HAY CREEK VALLEY

FINAL GRADING & EROSION CONTROL PLANS

PCD FILE #: SF2324

TITLE SHEET

DESIGNED BY:	CVW	SCALE	
DRAWN BY:	CVW	HORIZ.	1" = 40'
CHECKED BY:	JAO	VERT.	N/A
DATE ISSUED:	DECEMBER 2023	DRAWING No.	GEC03
SHEET	06 OF 12

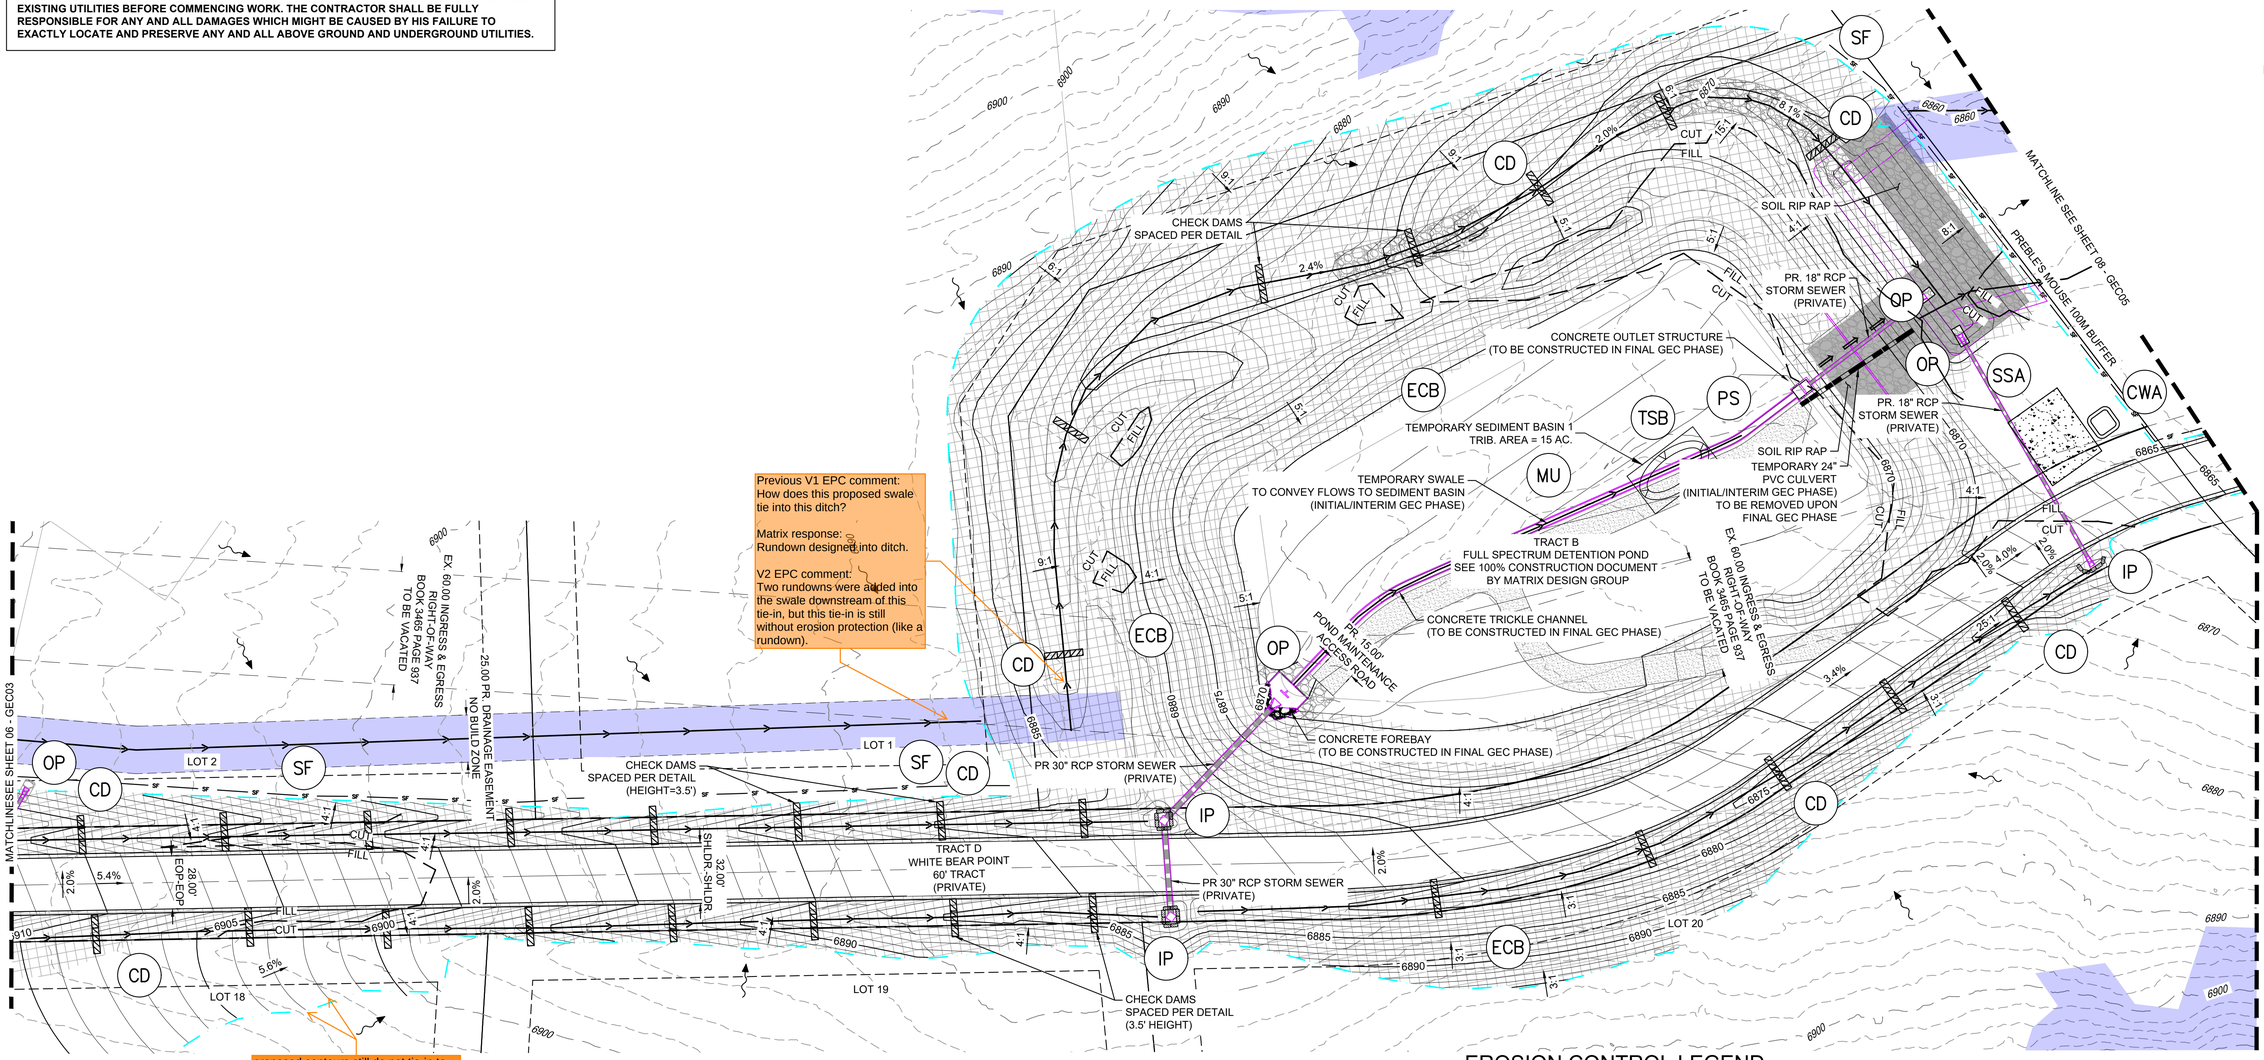
Previous V1 EPC comment:
How does this proposed swale tie into this ditch?

V2 EPC comment:
Two rundowns were added into the swale downstream of this tie-in, but this tie-in is still without erosion protection (like a rundown).

proposed contours still do not tie-in to existing contours at LOD properly. Typical comment throughout the GEC Plan sheets.

Matrix response:
Rundown designed into ditch.
